I live at Freeling House on the Hilgrove Estate and I would like to strongly object to proposals to clad Farjeon House, Dobson Close, Castleden House and Gillies House on the Hilgrove Estate with external wall insulation. (Ref: 2015/4041/P).

Examples of EWI work recently carried out by the London Borough of Camden

1 – 48 Greenwood. Pages 1 - 13

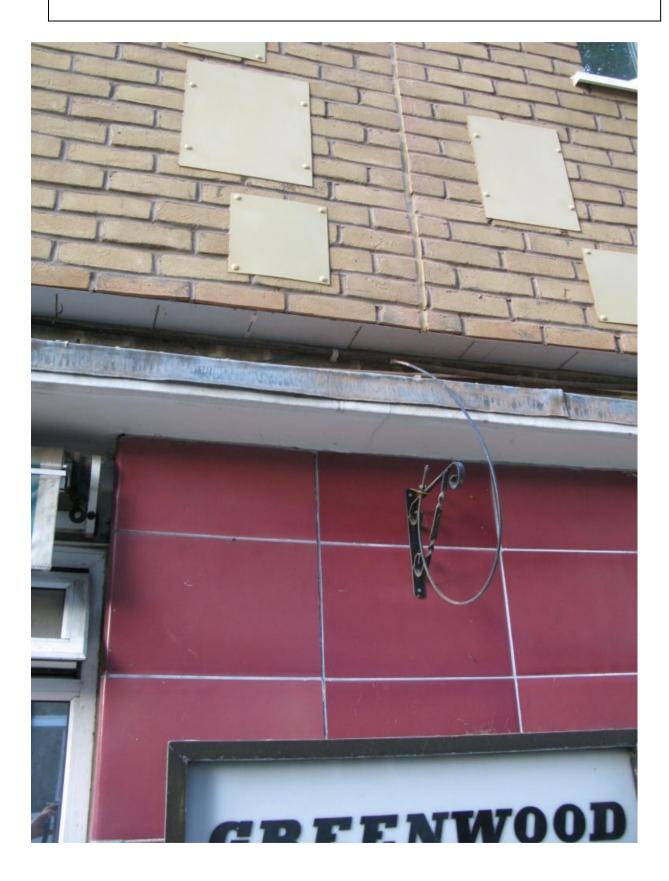
Close up showing metal/plastic fittings which have been attached to brick slips, gap above front entrance and loose wires which have been left hanging down.

Close up showing wonky brick work and irregular pointing which could allow water penetration.

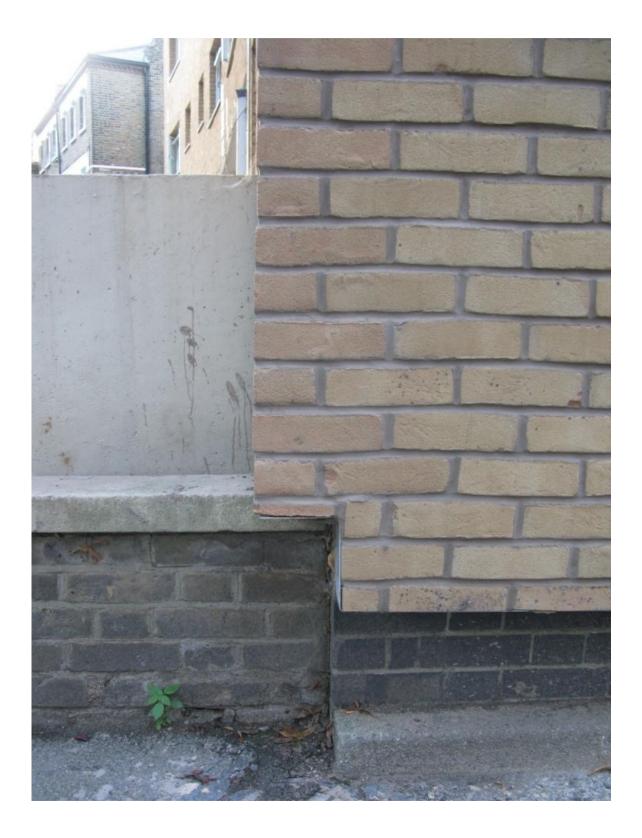
Unattractive design feature. Little thought has been given as to where the brick slips should end (as in what is the normal shape of a brick), or what the shape its cut into will look like once applied. The aluminium on the left does not appear to go right to the end of the slips.

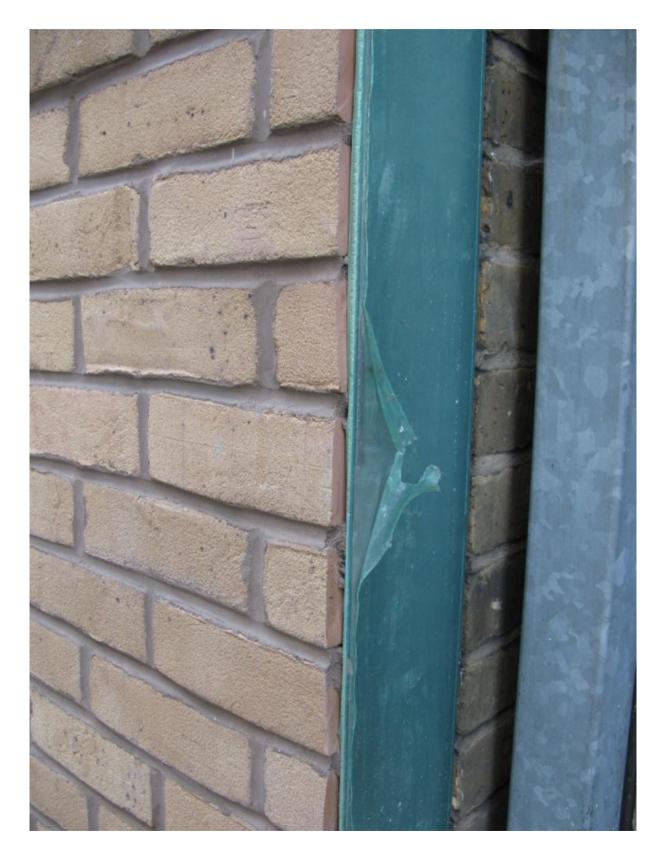
Irregular brickwork – both in terms of how they sit horizontally and how they sit vertically. No-one has bothered to remove plastic from aluminium (?) sheeting.

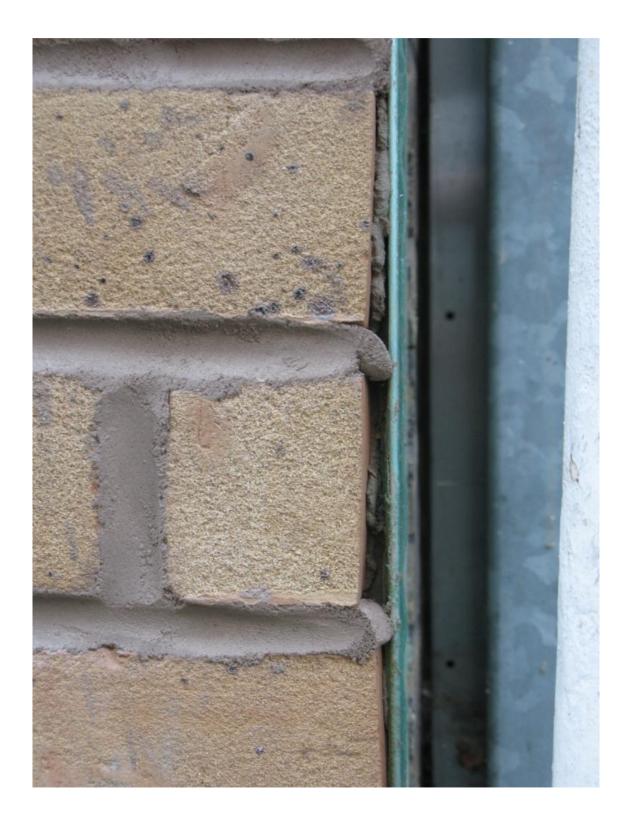
Gap between brickwork and side aluminium sheet. Poor finish of pointing at end of bricks.

Wonky brick work and gap between aluminium (?) sheet.

Uneven brick work halfway up side wall.

Stained brick work

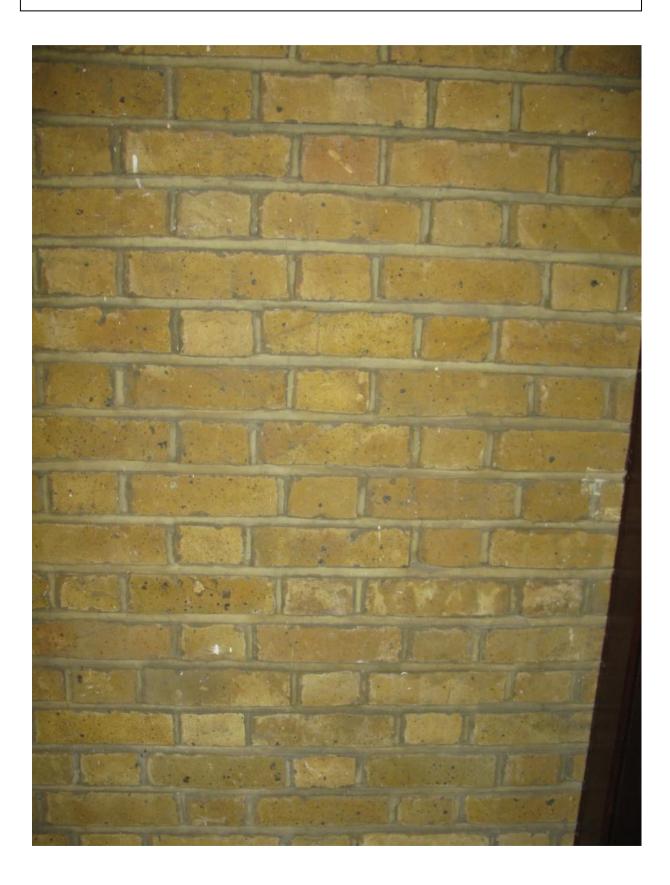
Unattractive design and poorly applied pointing work between bricks.

NB: One of the screw covers is already missing.

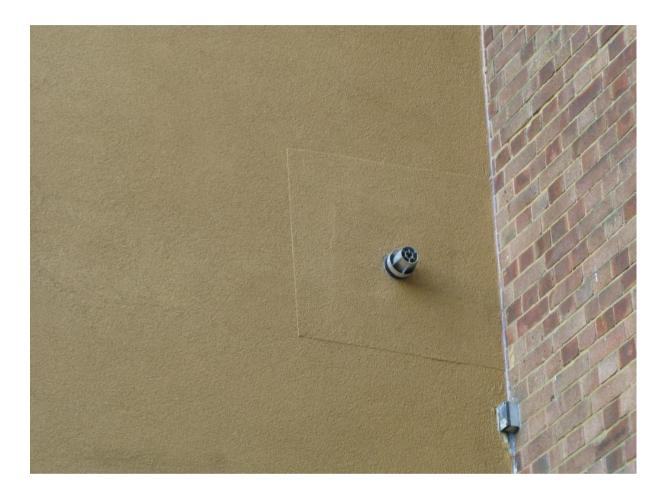
Sticking plaster effect of placing a layer of the same colour on top of another layer around extractor. Poor finishing and design means that the extractor fan is not even central to the "sticking plaster".

Dangerous sharp edges to left of entrance. Also, an unattractive design feature.

Gap between render and entrance making an unattractive design feature.

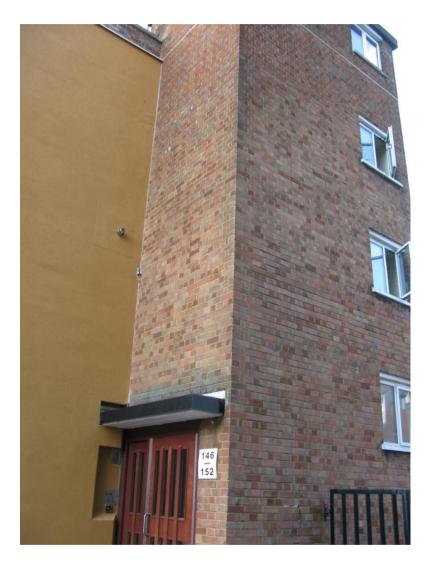
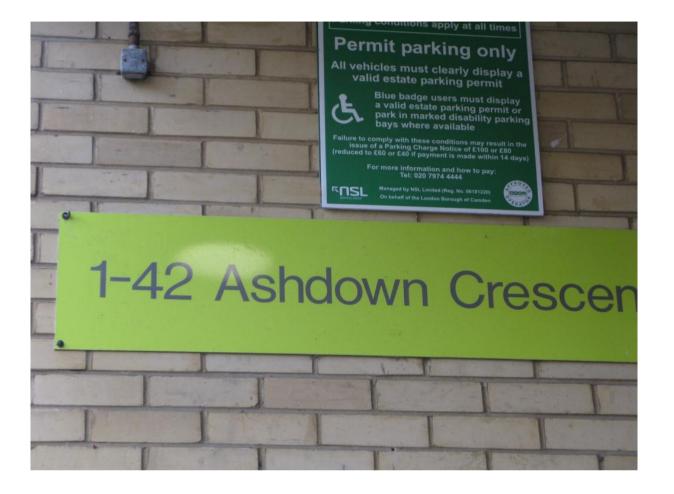
New rendering mixed with old brick work.

Already showing signs of deterioration.

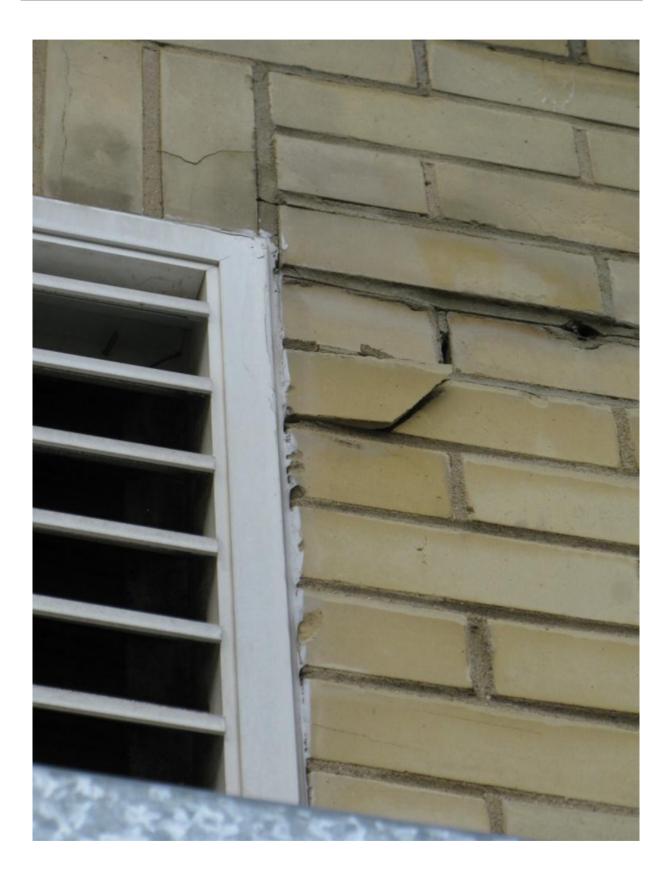
Detail of wall above front entrance. Not sure what this wall is made of or if done alongside recent works. Cracks in brickwork, top layer (of cladding?) coming away in parts, pointing missing in places. From a design point of view, it does not sit well with new plastering which has been carried out beyond entrance hall.

Details of wall to left of entrance hall. The top layer of the wall has come away at the bottom of the wall. Unclear if these walls have been recently clad or if they have been done previously and not upgraded when recent cladding has been done.

Details of area by entrance hall. Walls are stained. Unclear if these walls have been recently clad or if they have been done previously and not upgraded when recent cladding has been done.

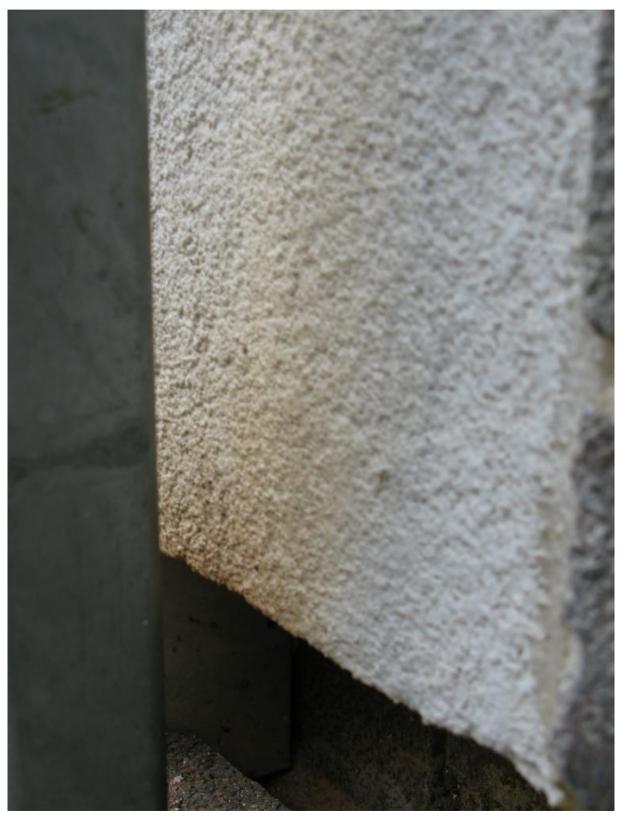
Plasterwork behind metal (aluminium?) fixture by entrance shows discolouration – rust marks?

Area around fixture at front of building is badly filled and painted which could allow moisture to enter the building.
